Vermont Agency of Transportation
RECEIVED
CK'D BY NA OK'D BY JS
August 13, 2015
RESUBMIT YES Rejected
BY KH DATE 8-16-2015

I-91 AFTER CLOSURE PLANS

PROJECT NAME:	HARTFORD	FILE NAME:	sl2a026CutSheet.dgn	PLOT DATE:	08/12/15
PROJECT NUMBER:	IM 091-2(79)	PROJECT LEADER:	K. HIGGINS	DRAWN BY:	B. LYON
		DESIGNED BY:	B. LYON	CHECKED BY:	S. SAWYER
			I-91 AFTER CLOSURE PLANS	SHEET	1 OF 3

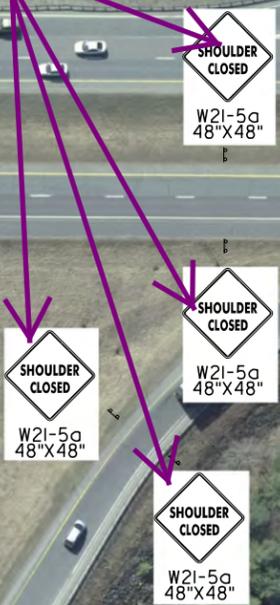
Please refer to Figure 6H-5 TA-5 of the 2009 MUTCD and

If each shoulder is worked on separately then separate plans would be easier to follow.

Right/Left Shoulder Closed/ XX FT

1000 ft spacing

500 ft spacing

Add a distance plaque

Right Shoulder Closed Next XX Feet (gate posted signs)

Adding a type 3 barricade with diagonal angling left for ramp traffic after the taper is recommended.

PROJECT NAME:	HARTFORD	FILE NAME:	sl2a026CutSheet.dgn	PLOT DATE:	08/12/15
PROJECT NUMBER:	IM 091-2(79)	PROJECT LEADER:	K. HIGGINS	DRAWN BY:	B. LYON
		DESIGNED BY:	B. LYON	CHECKED BY:	S. SAWYER
		I-91 AFTER CLOSURE PLANS			SHEET 2 OF 3

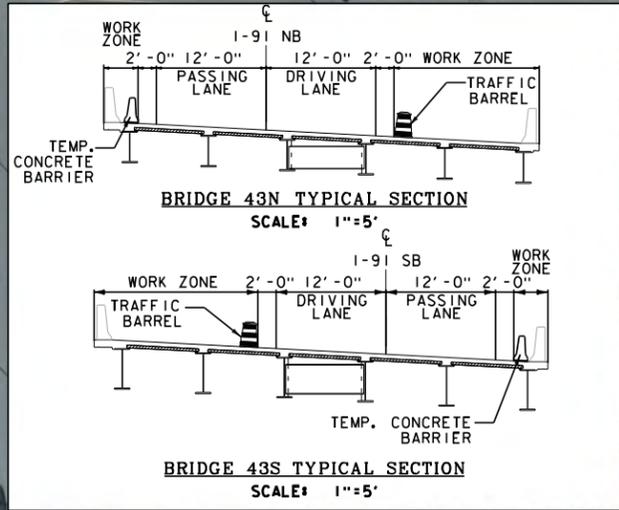
If paved shoulder is greater than 8 ft channelizing devices should be used to close the shoulder in advance of the merging taper to direct vehicular traffic to remain within the traveled way.

This looks more like work in the vicinity of a ramp MUTCD Figure 6H-42 (TA-42) Not a shoulder closure

Shoulder work Ahead/ Next XX Feet to be place 500 feet in advance of the end of the taper and the beginning of the tangent

See comments from sheet 1 regarding taper lengths.
